January 15, 2014

Re: Arlington Storage Company, LLC, Seneca Lake Storage Facility Gallery 2 Expansion Project, Docket CP13-83, Expert Geologist Report

II. Charles Jacoby's publicly available articles describe the development of Caverns 30 and 31.

PROFILE OF WATKINS GLEN
BRINE WELLS NO. 27, 28, & 30

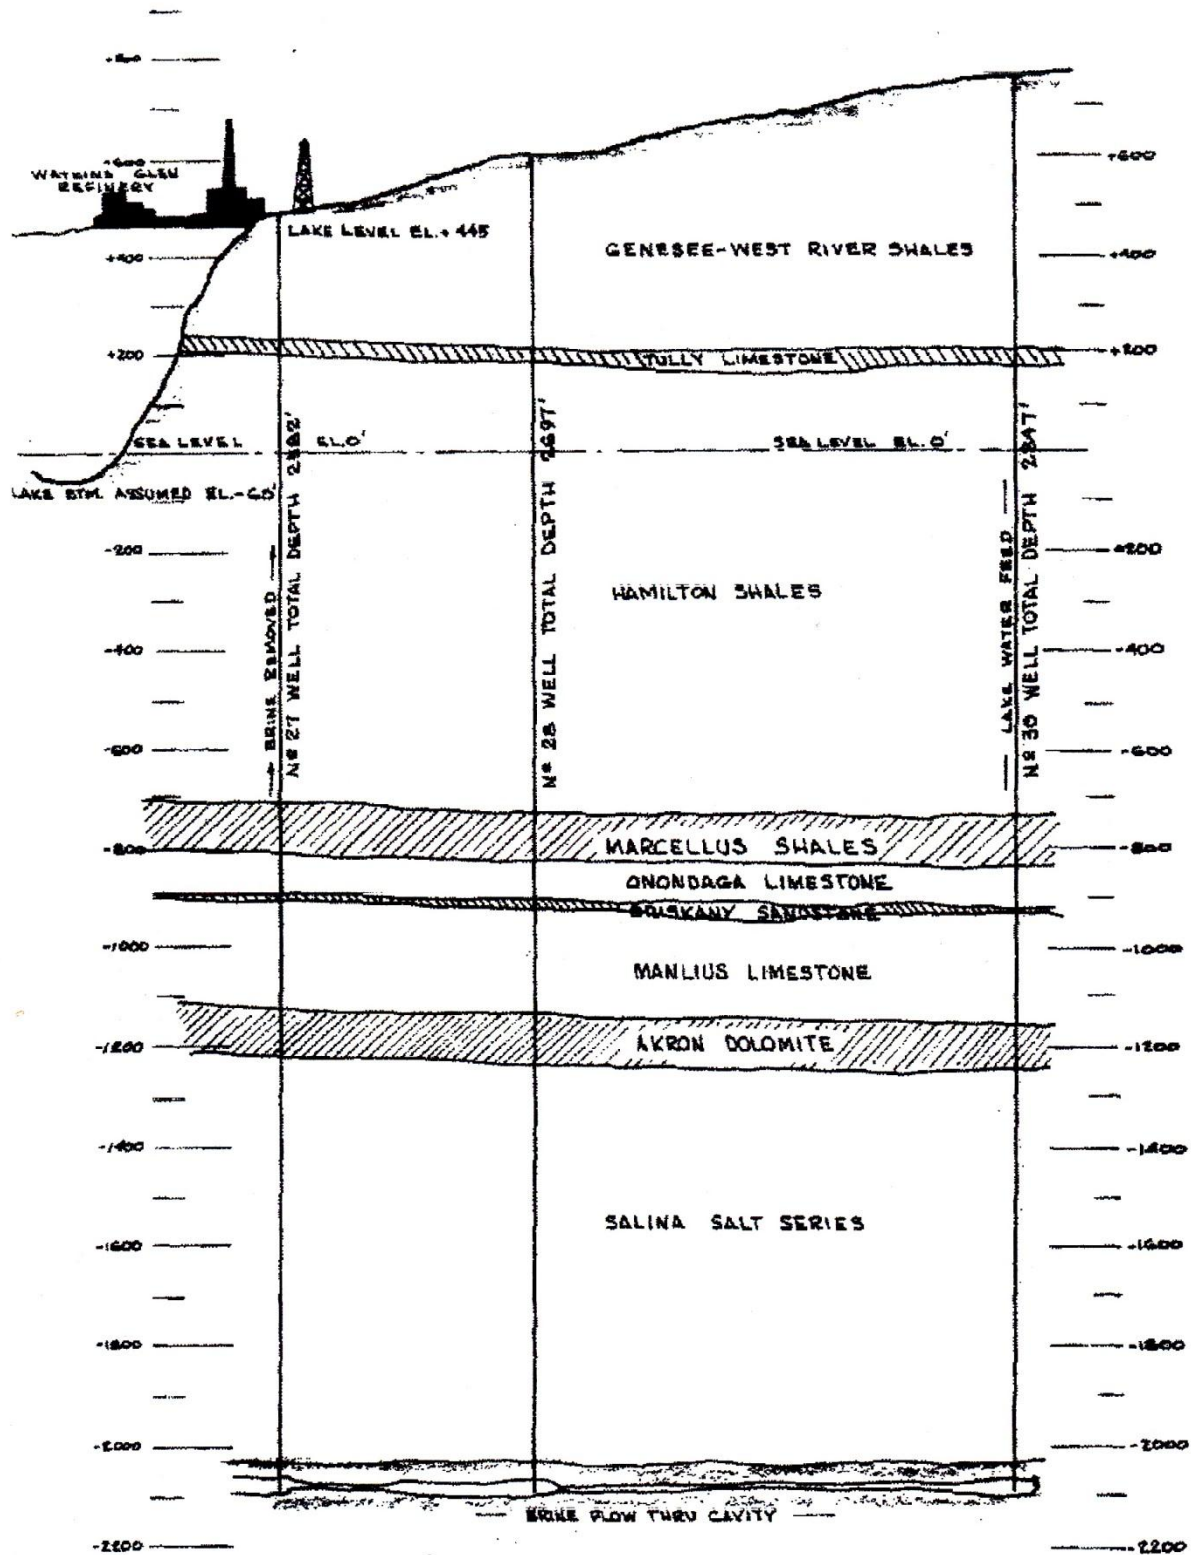
The next cross-section from the Jacoby 1969 paper (his Figure 2, attached as Exhibit 3) shows the situation in June of 1964. Initially, Well 30 and Well 31 were both hydraulically fractured at the lower B2 salt layer, but the process failed to connect the two wells by way of the lower B2 salt (see near-well fracture at wellbore depicted at the lower B2 of Well 31). “The connection between the two wells was finally completed in the **fault zone** in the **overthrust block** of B2 salt.” (Jacoby, 1969) (emphasis added). Jacoby wrote extensively about using an understanding of this thrust fault geology to design hydraulic fracture programs and to take advantage of a weakened fault zone path to a target well. And with regard to these wells, he notes: “At the points on the cross-section where faulting has been confirmed, fault zones several feet in thickness are present.” (Jacoby, 1969) Following fracturing, communication was established between Wells 30 and 31 and Gallery 2 solutioning development began. The cross-section of Jacoby’s Figure 2 shows that the two connected caverns were being used for LPG

storage in 1964 as shown by the propane legend symbol in the upper part of Cavern 31 and at the top of Cavern 30. The vertical extent of the hydraulically fractured fault zone connecting Cavern 30 to Cavern 31 is discussed only qualitatively in the paper, but the areal extent of the hydraulic fracture connection must be significant since publicly available mapping⁵ shows Well 45 to be offset from a straight line connecting Wells 30 and 31, and it intercepts the fractured fault zone connection and will be used in the Arlington plan as a monitor well. While on the subject of the hydraulically fractured connection between Wells 30 and 31, there is a cross-section in another Jacoby paper that shows a connection between Well 30, Well 27, and Well 28 (Jacoby, 1961, Figure 2 attached as Exhibit 4). That paper is a discussion of the brine mining process and the wells are not discussed specifically. If there is or was a connection, that would connect Gallery 2 to Gallery 1, and this would be a significant concern. Arlington must have all the original records, and it could provide that information from the original source to resolve this question. The connection by way of a fault zone that affects both Well 30 and Well 31 and beyond, and perhaps way beyond, is not discussed in the public Arlington documents that I have reviewed.
